SANTA FE INTERCHANGE

FATAL FLAWS

SW / NE PARCLO (A)

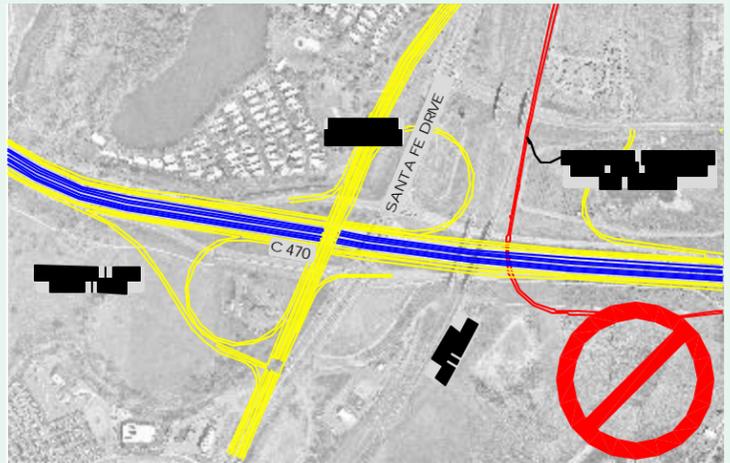
- Loop Ramp in Northeast Quadrant Does Not Meet Design Standards
- Indirect Westbound Off-Ramp Access To Santa Fe

SW / NE PARCLO (B)

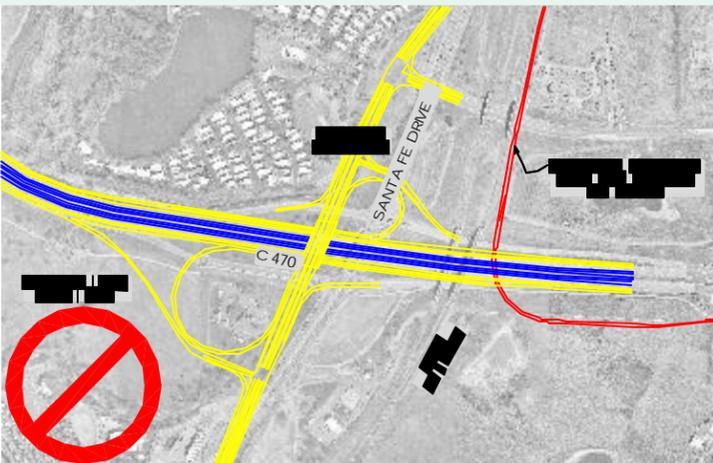
- Potential Impacts To Wolhurst Subdivision
- Indirect Westbound Off-Ramp Access To Santa Fe

SW / NE PARCLO (C)

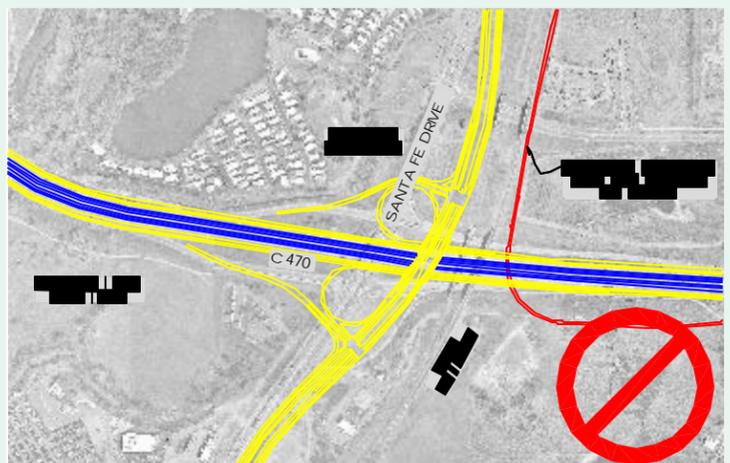
- Loop Ramp In Northeast Quadrant Does Not Meet Design Standards
- Potential Impacts To Wolhurst Subdivision
- Substandard Intersection Spacing

SW / NW PARCLO

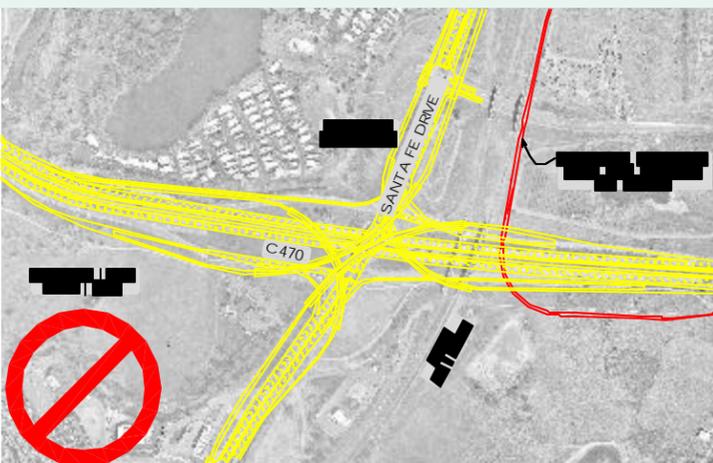
- Loop Ramps Do Not Meet Design Standards
- Potential Impacts To Wolhurst Subdivision
- Insufficient Spacing Between Loop Ramps
